Mixed Use Development, 1 Lawson Square, Redfern

*Section 4.55 (1A)
Modification
Assessment
(SSD 5249 MOD 8)*

February 2020

Figure 2 | Revised lift core arrangement over Levels 3-5 (Base source: Approved Plans MOD 7 and Applicant's Modification Report).

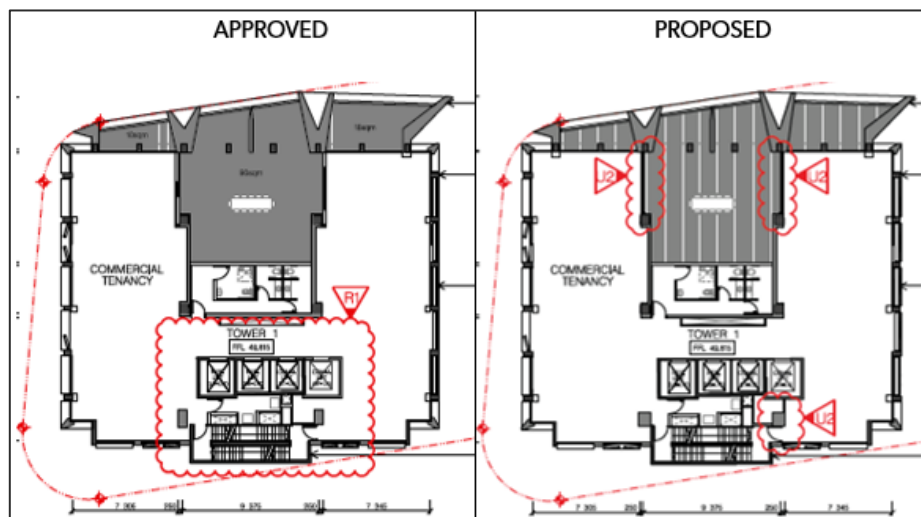
- amend the lift core columns associated with commercial tenancies on levels 1-5 (**Figure 2**)
- amend the glazing on the eastern and western facades of commercial tenancies on Ground and Level 1 (**Figure 4**)
- reconfigure five 1 bedroom and three 2 bedroom units to create three 3 bedroom units over Levels 15 to 17
- create balconies attached to the new 3 bedroom units on Levels 16 and 17
- create a roof terrace at level 18 for use of the 3 bedroom unit on level 17 (**Figure 3 and 5**).

Figure 4 | Revised fenestration and glazing to the west elevation at Ground and Level 1 (Base source: Approved Plans MOD 7 and Applicant's Modification Report).

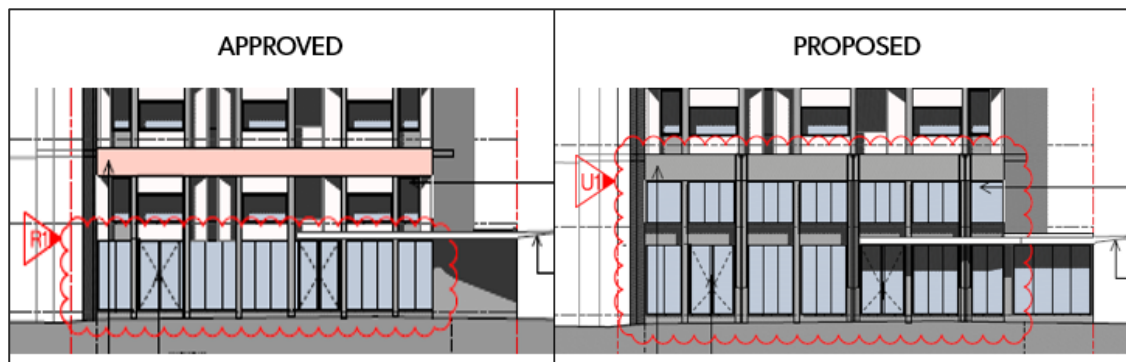
- the changes to fenestration at ground and first-floor level would match the approved commercial façade of Tower 2 and be in keeping with the design intent of the overall development.

Figure 5 | Reconfigured units, new balconies and roof terrace (Base source: Approved Plans MOD4 and Architectural Plans).

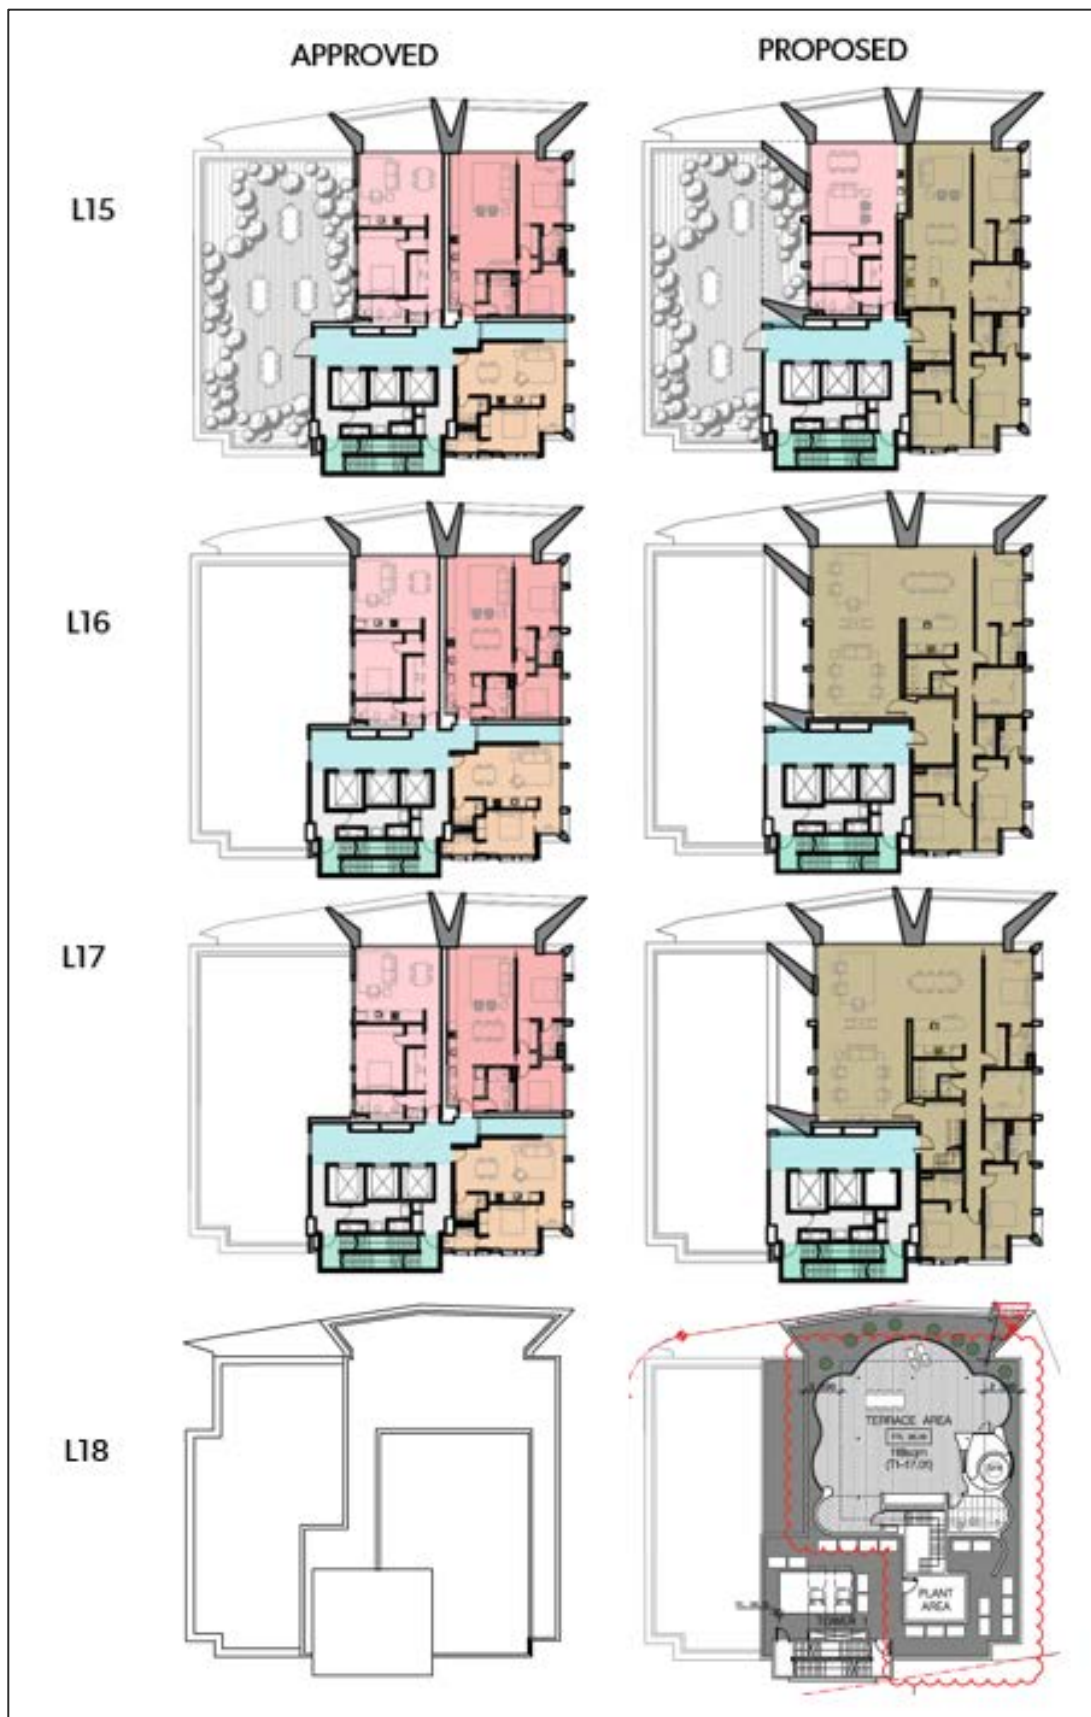
- the roof terrace, lightweight shade structure and privacy screen to Level 18 would match the approved height, layout and materiality of the adjacent roof terrace on Tower 2, approved under MOD 4

- the proposed new roof structures have a maximum height of RL 98.85 consistent with the approved rooftop plant which was considered acceptable in the assessment of the original development application

- the roof structure is setback 2.5 m to 3.725 m from the northern, eastern and western elevations and would be screened by the approved plant, stair and lift overrun so as not to be readily visible from the public realm

- the proposed balconies are discreetly located, inset between the lift core and north facing balconies and are in keeping with the design of the approved building
